HISTORIC AND DESIGN REVIEW COMMISSION

HDRC CASE NO: 2018-018
COMMON NAME: Aztec Theater
ADDRESS: 104 N ST MARYS
LEGAL DESCRIPTION: NCB 116 BLK LOT 2 THRU 9, & W 3.6 FT OF ALLEY
ZONING: D, HS
CITY COUNCIL DIST.: 1
LANDMARK: Aztec Theater
APPLICANT: Russell Williams, RA/Overland Partners
OWNER: Sam Panchevre/Aztec Family Group, LLC
TYPE OF WORK: Exterior modifications, construction of a rooftop addition, construction of a cantilevered overlook
APPLICATION RECEIVED: May 17, 2019
60-DAY REVIEW: July 16, 2019
CASE MANAGER: Edward Hall
REQUEST:

1. Construct an overlook terrace on the north façade to extend over W Crockett Street.
2. Construct a rooftop addition to feature an overall height of approximately twenty-five (25) feet.

HDRC PACKAGE — 17 MAY 2019

SECTION AT OVERLOOK TERRACE

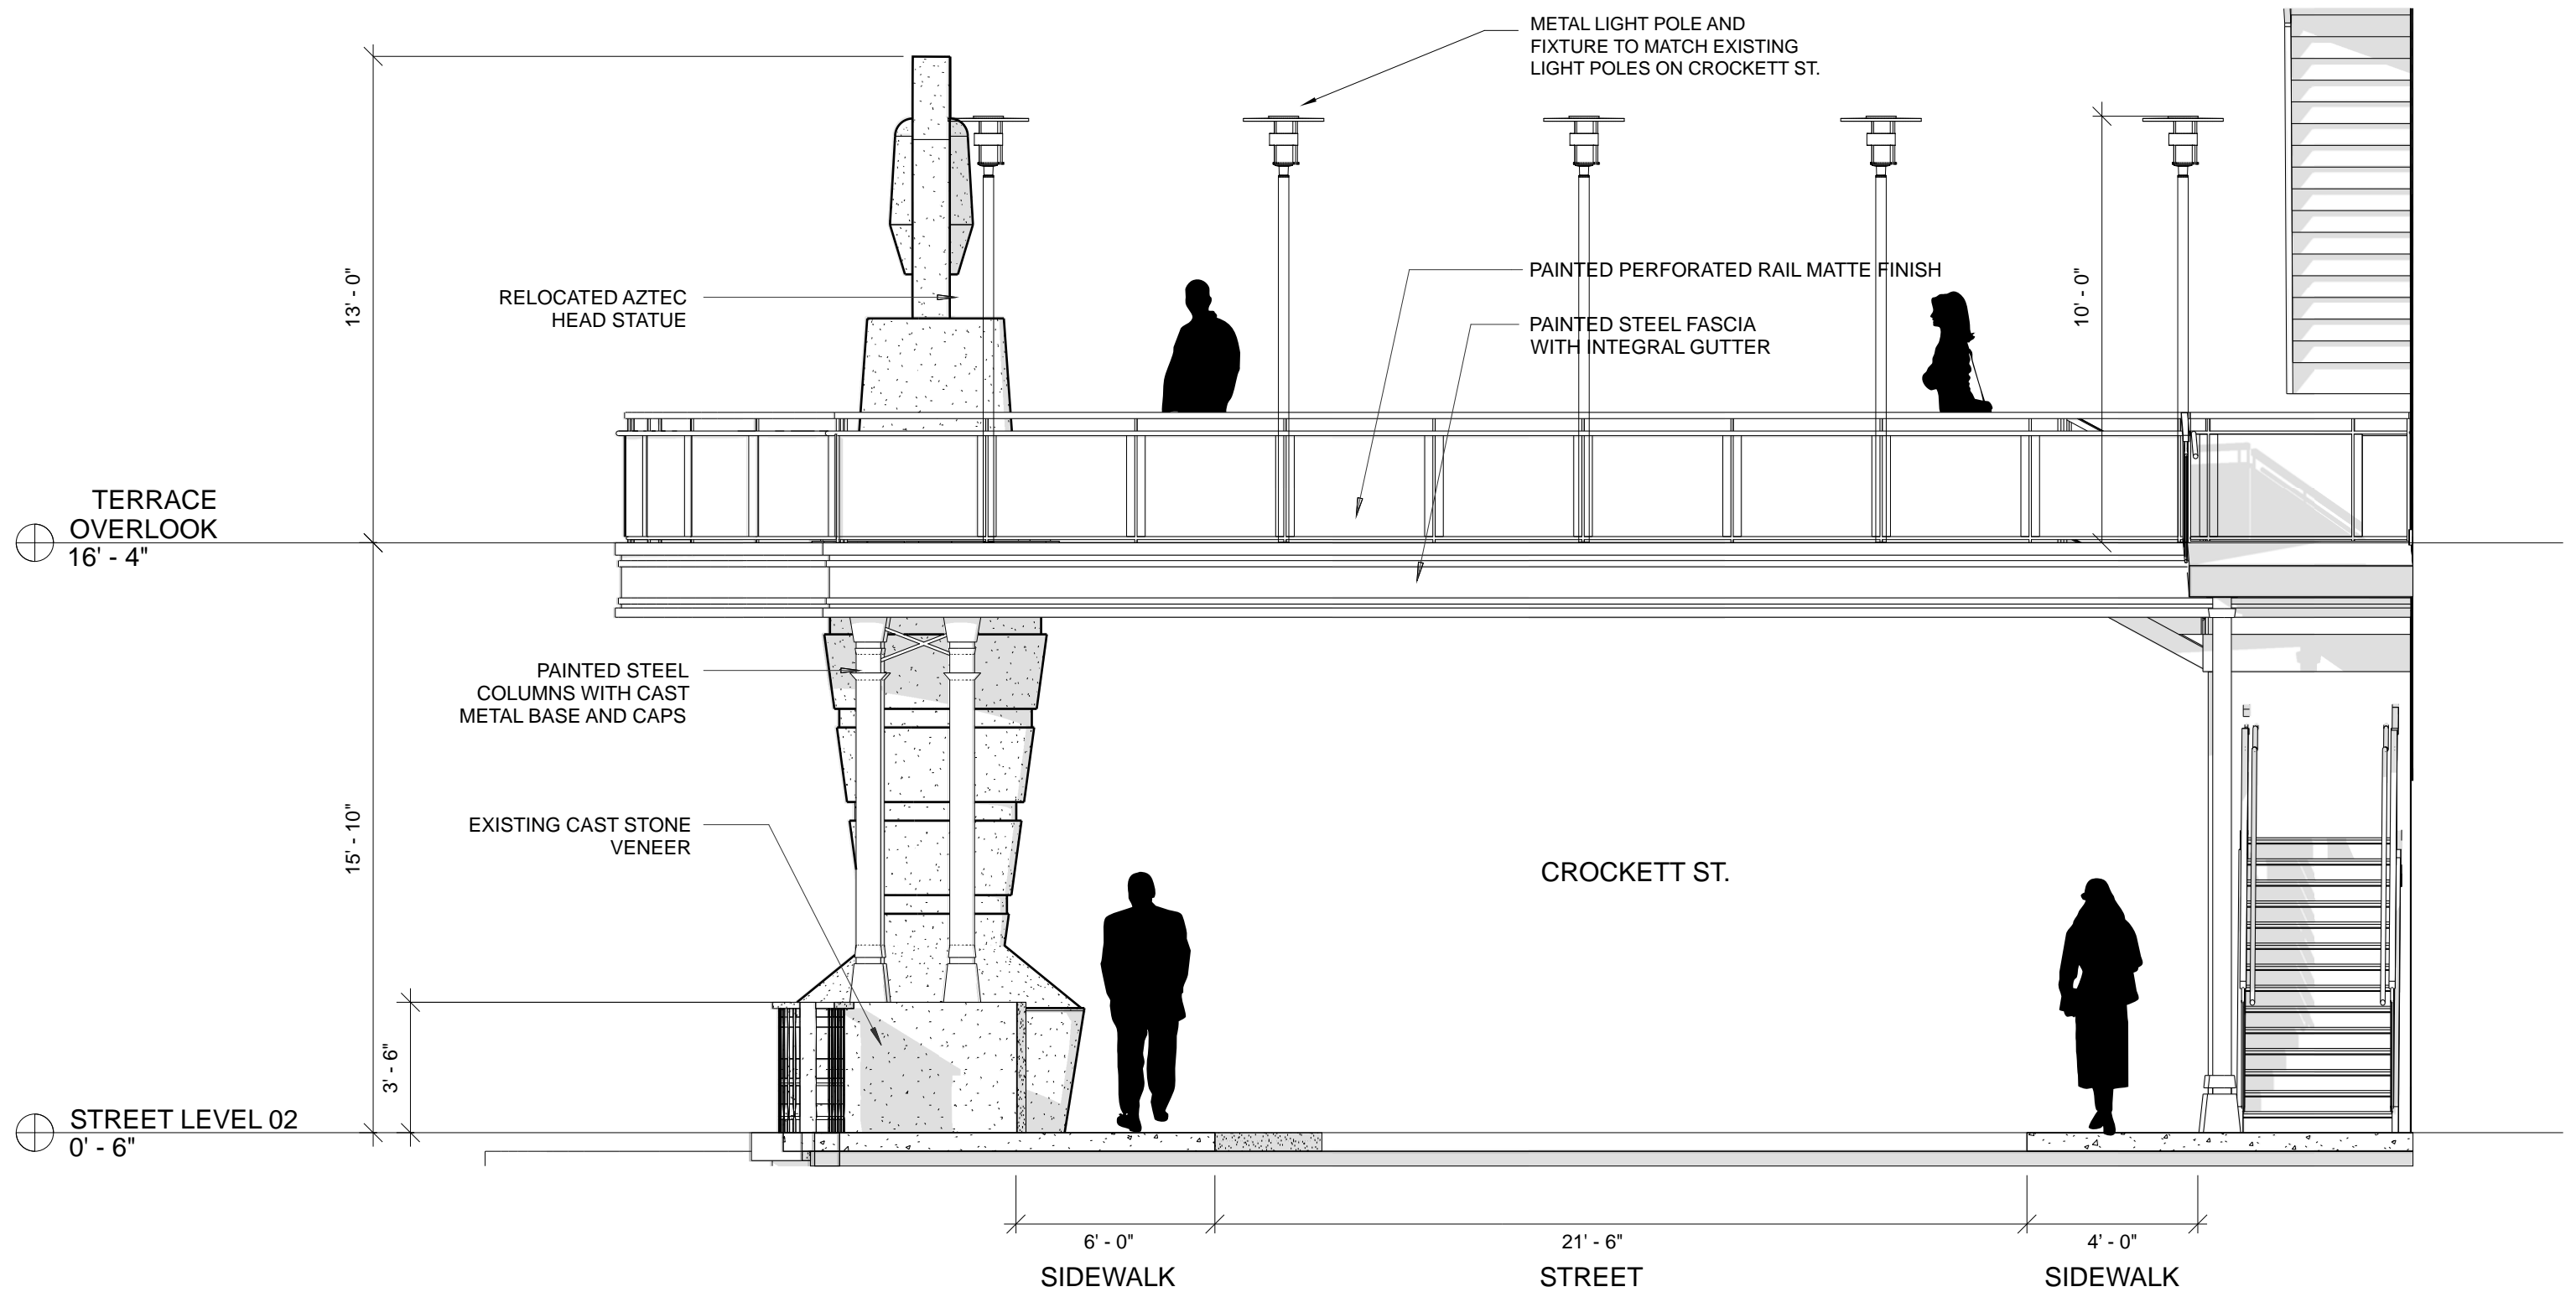
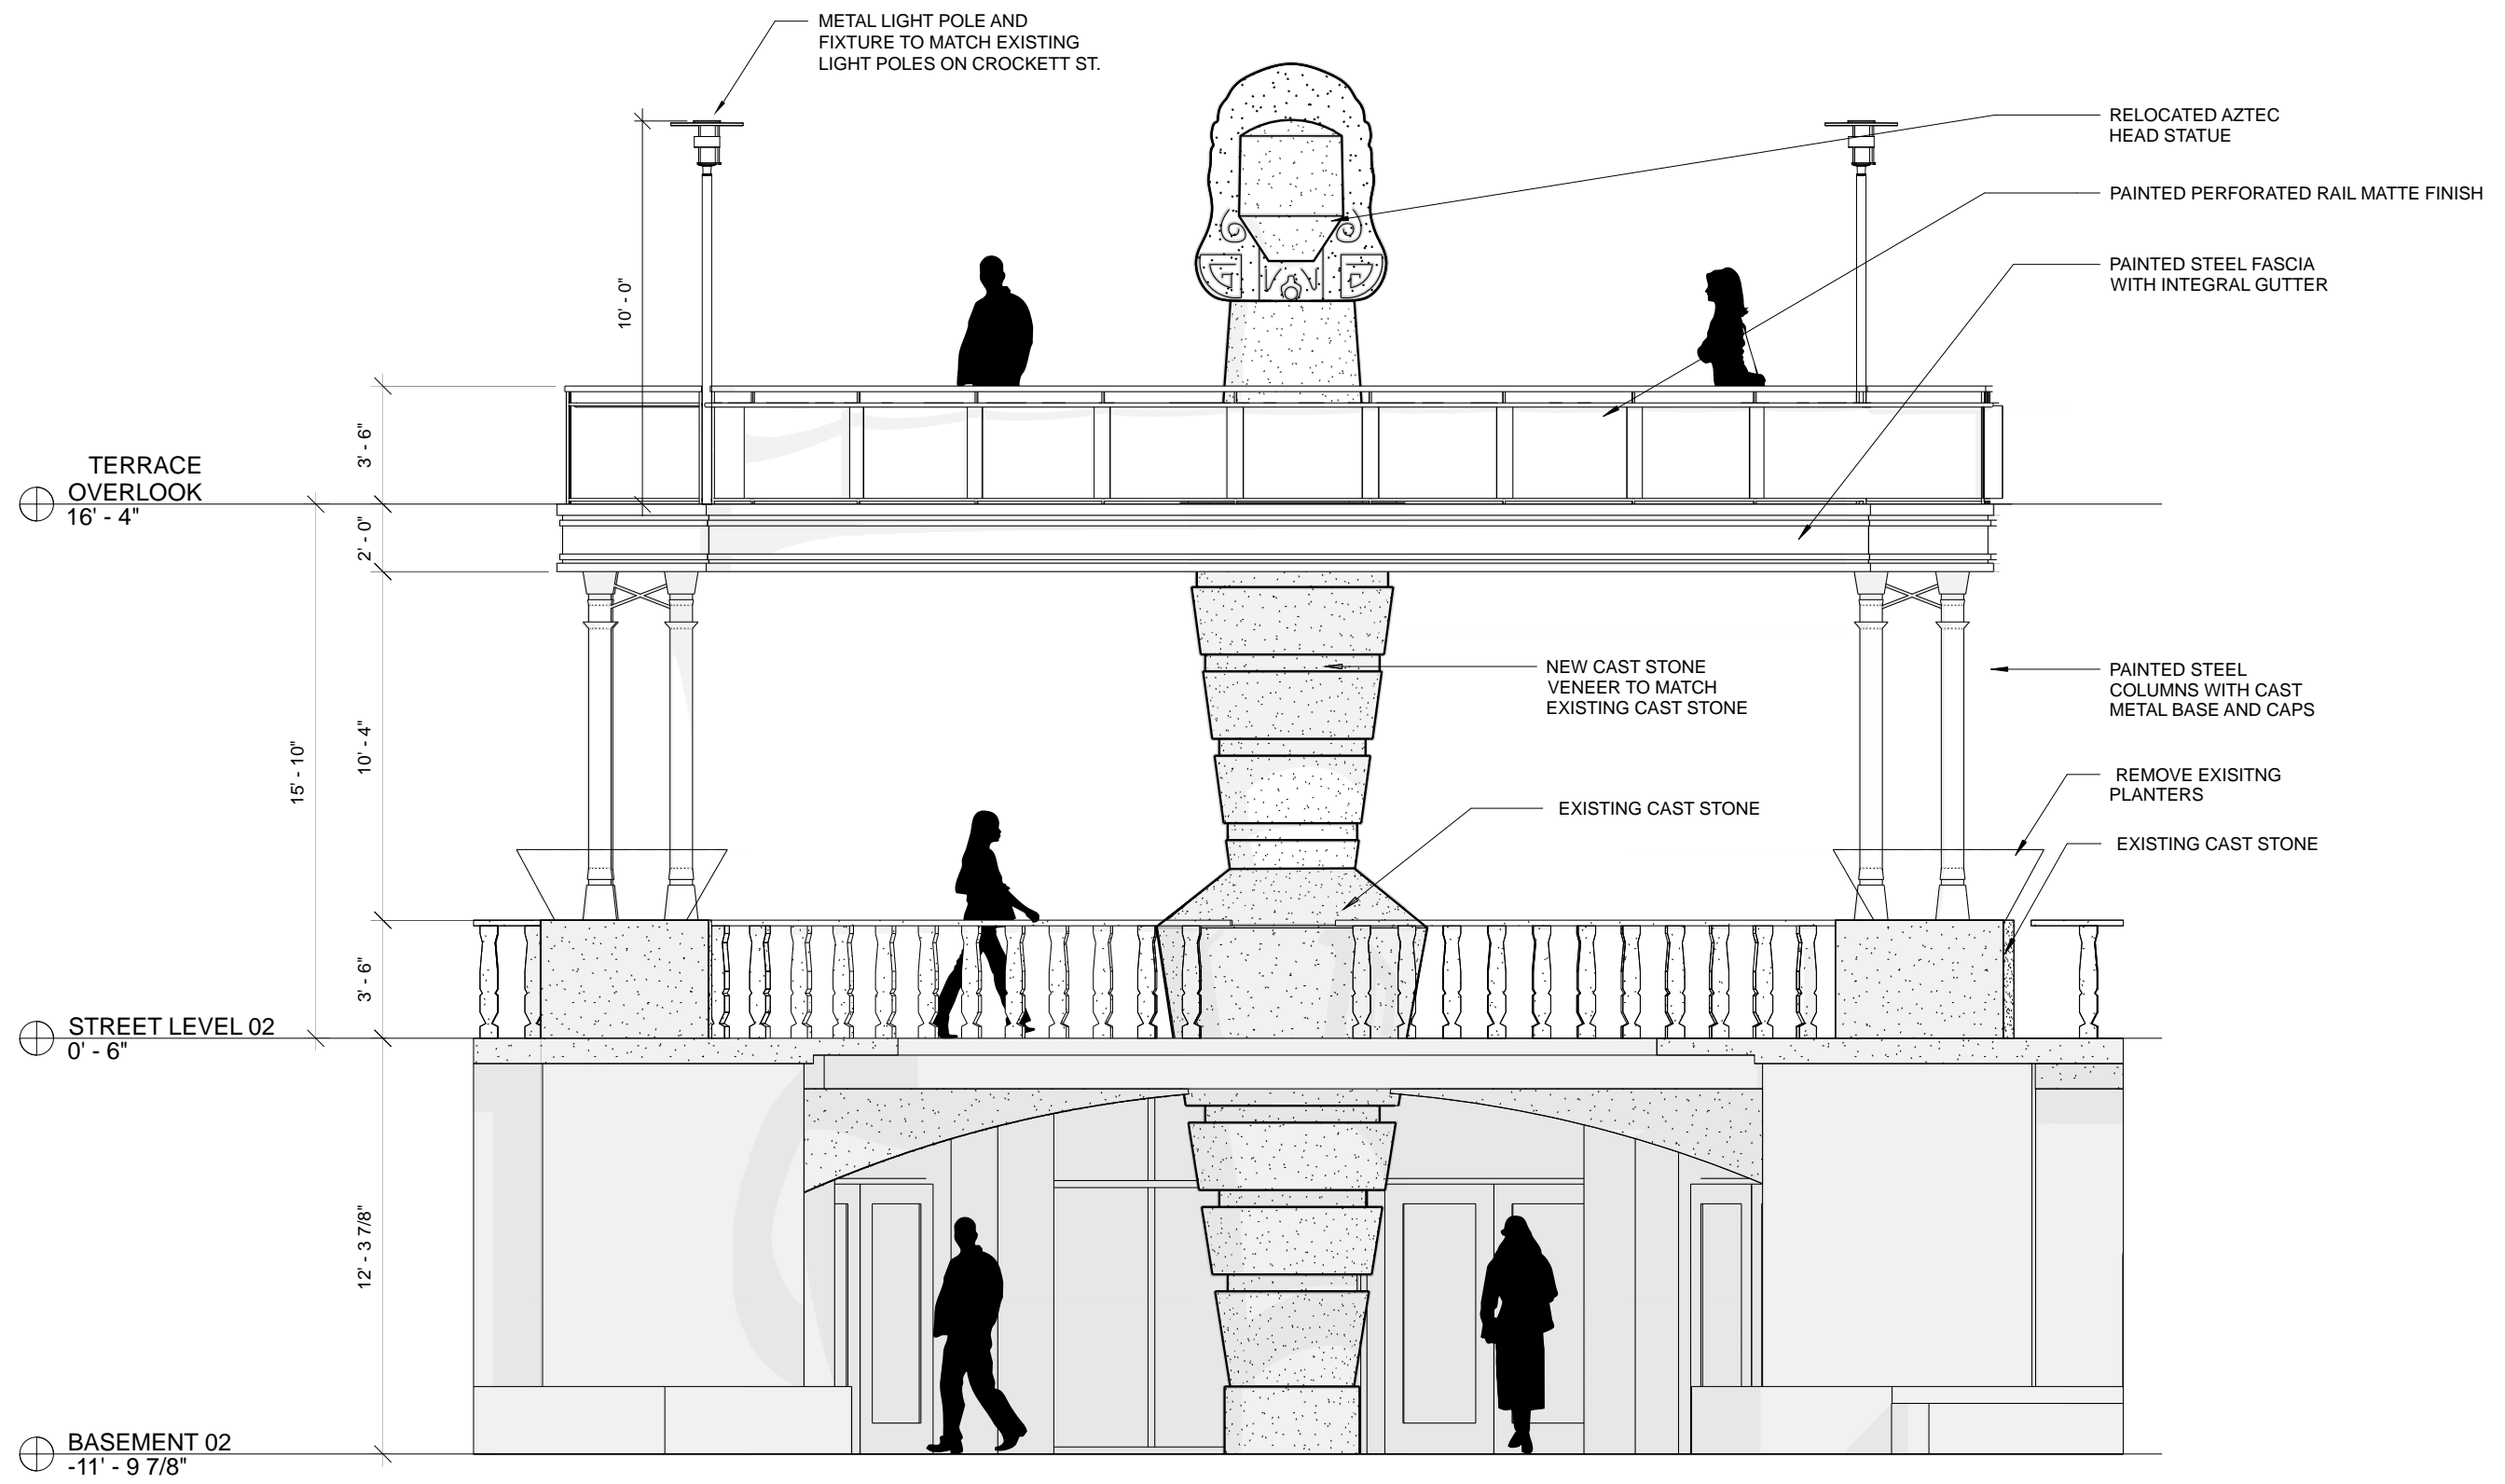
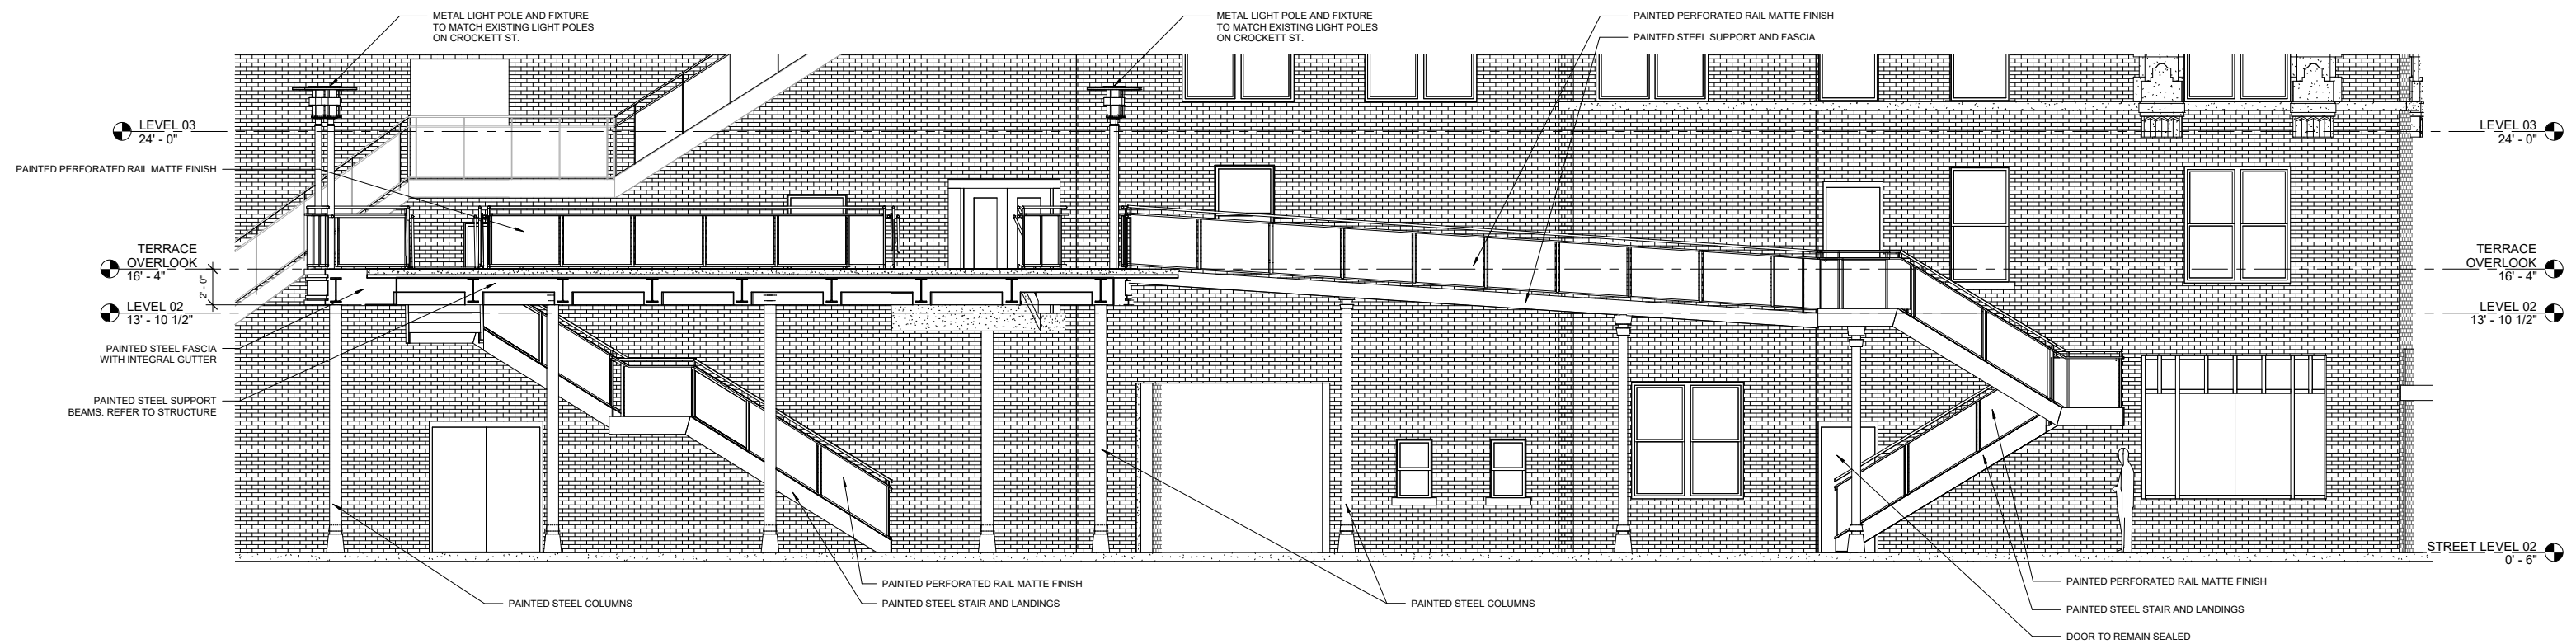
- d. **OVERLOOK TERRACE** – Above W Crockett Street along the north façade of the structure, the applicant has proposed to construct an overlook terrace that will extend from the historic structure across W Crockett Street to the existing Aztec sculpture at the public right of way on the San Antonio River Walk side W Crockett. The applicant has proposed to reposition the existing Aztec sculpture by raising it to the height of the overlook terrace. The applicant has noted materials that include painted, perforated rail systems, painted steel columns and cast stone veneer to match the existing. Generally, staff finds the proposed overlook structure and its proposed materials to be appropriate.

- e. **OVERLOOK TERRACE** – The applicant has proposed for the overlook terrace to feature a stair system to facilitate pedestrian traffic to and from the street level. Staff finds the proposed stair system to be appropriate; however, staff finds that the proposed stair should be installed in a manner that does not damage the historic masonry façade and does not interrupt pedestrian traffic on the sidewalk below. The applicant has noted that the stair will feature a structural system that is incorporated into that of the overlook terrace's system. Additionally, the applicant has noted that the staircase will feature approximately a four (4) inch separation from the historic structure's façade; however, tying to the historic structure's structural system may be required. If this is the case, staff finds that this should be done in a manner that is a least impactful to the historic structure as possible.

- i. That the proposed overlook terrace's stairs be installed in a manner that does not damage the historic structure and does not interrupt the flow of pedestrian traffic on the sidewalks below. At least six (6) feet of uninterrupted sidewalk width should be provided on the sidewalk at all times. The applicant shall coordinate with the City of

San Antonio Center City Development Office, Transportation and Capital Improvements and the Disability Access Office in regards to the street level details, width of public walkways and public access across the site.
